**TOWN OF NEWBURGH
PLANNING BOARD
TECHNICAL REVIEW COMMENTS**

PROJECT NAME: CHADWICK WOODS – 5 LOT SUBDIVISION
PROJECT NO.: 19-02
PROJECT LOCATION: 174 ROUTE 300
SECTION 14, BLOCK 1, LOT 51
REVIEW DATE: 26 AUGUST 2022
MEETING DATE: 1 SEPTEMBER 2022
PROJECT REPRESENTATIVE: TALCOTT ENGINEERING/CHARLES BROWN

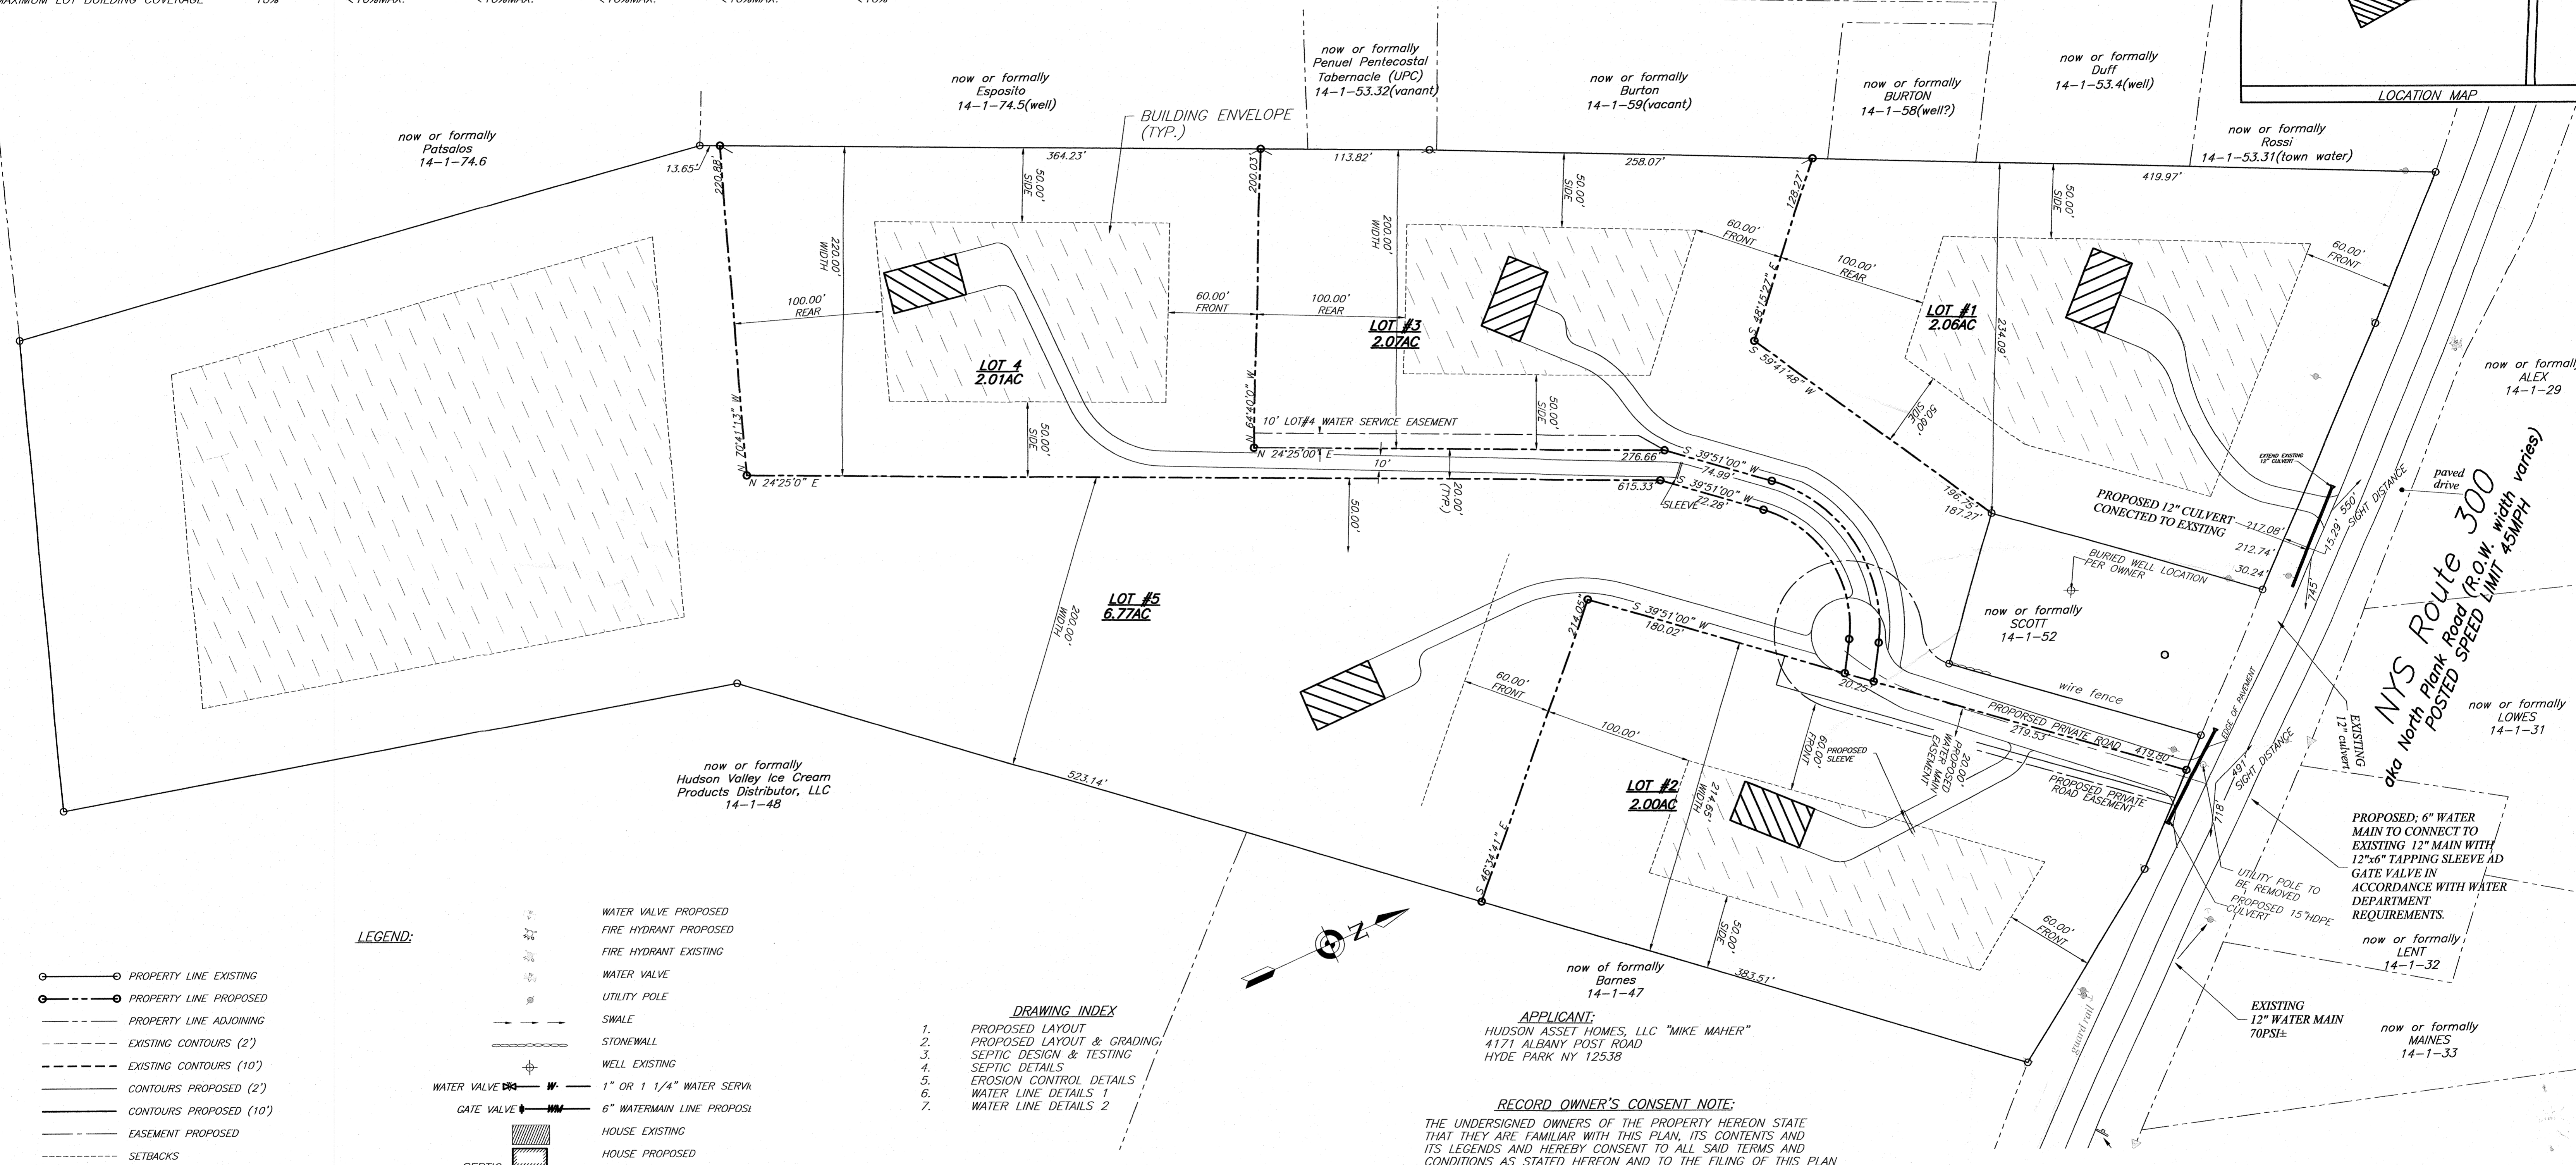
1. Dominic Cordisco comment on the ownership of Lot 5 for a portion of the private roadway should be received. Lot 5 owns a portion of the right-of-way however, none of the pavement. Lot lines could be slightly modified between Lots 4 and 5 to address this.

5. The plans have been revised to provide an easement across Lot 3 for the portable water service to Lot 1. This easement must be approved by Dominic Cordisco's office.

11. Label the Fire Access Passing Zone on Lot 5 driveway to ensure it construction.
12. Cost estimates for the private road must be submitted for security

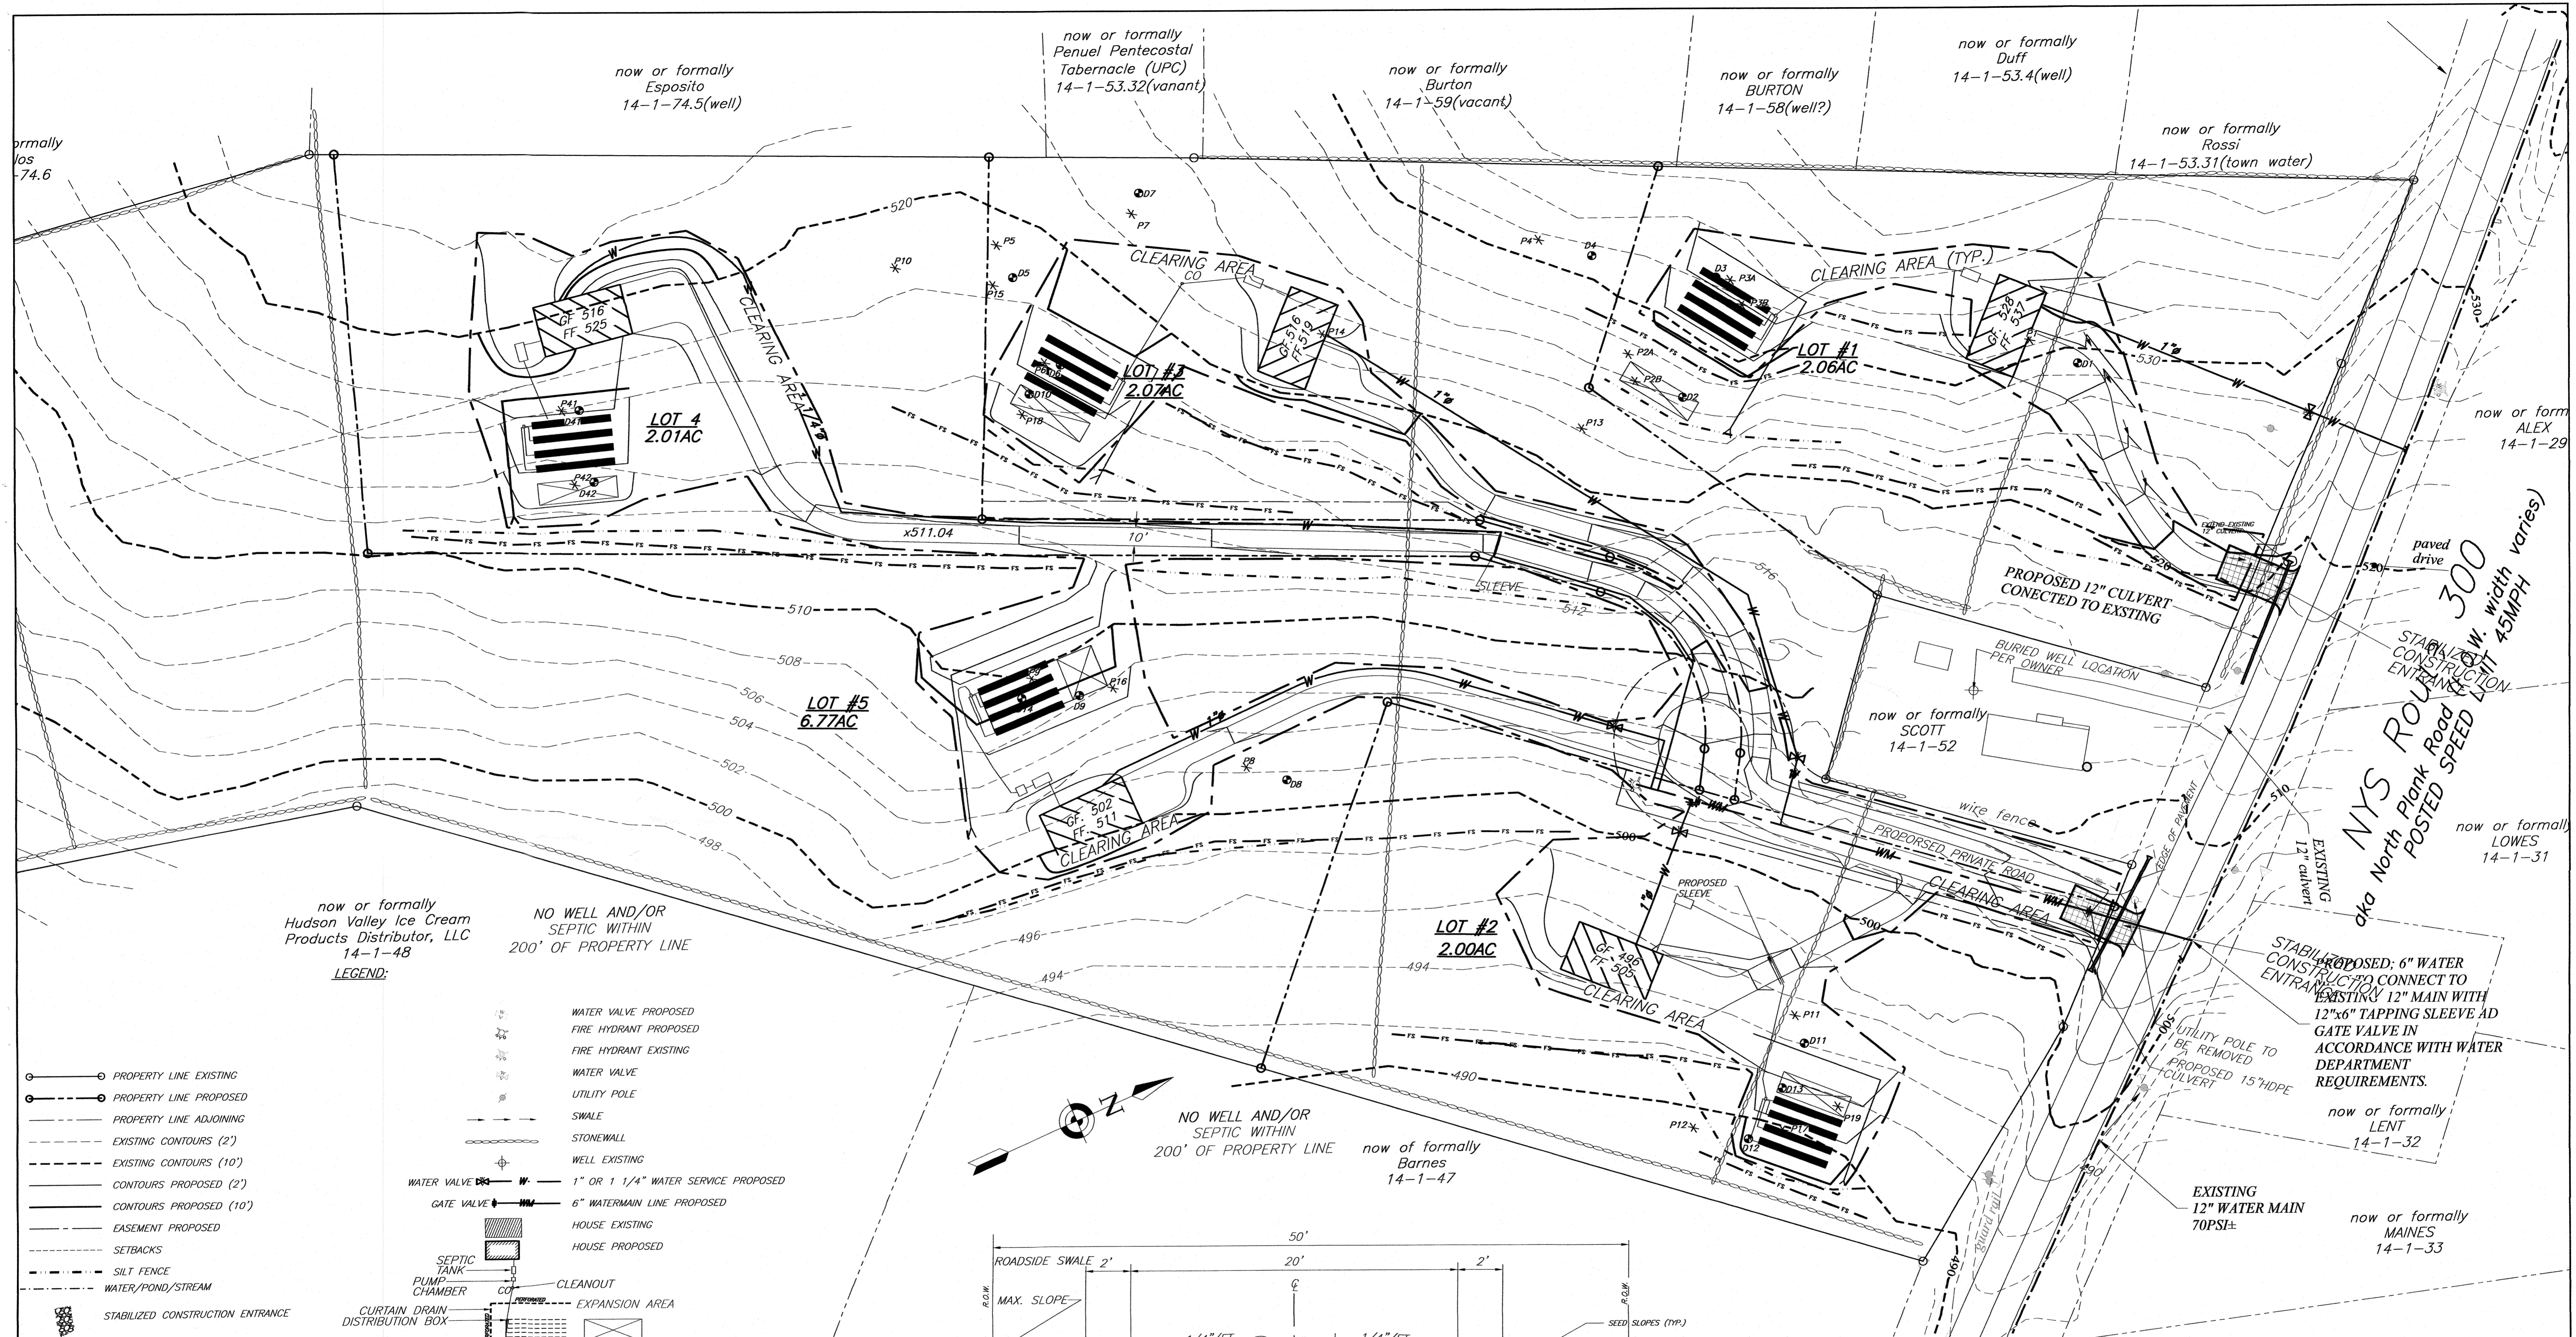
2. Private Road Access and Maintenance Agreement will be required.
3. Orange County Health Department approval for water main extension is required.
4. It is recommended the applicants label the Subsurface Sanitary Sewer Disposal Systems on Sheet C-101 as shallow absorption trenches per the design details.
